Technical Service Bulletin

Bolt Holes on Clutches Designed for Multiple Applications

PDL Cover Example

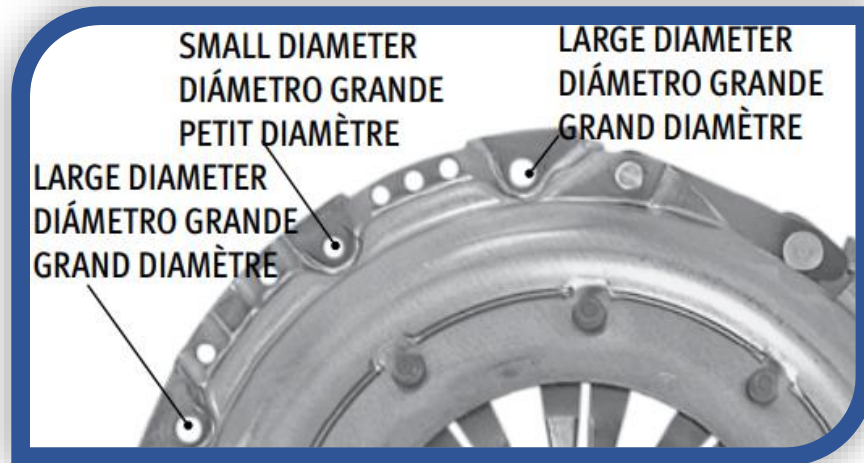
Some Platinum Driveline clutch kits contain a diaphragm spring clutch that replaces the original coil spring clutch. The original had six bolt holes whereas the Platinum Driveline replacement has nine holes. This variance is designed for use on multiple applications with different bolt patterns.
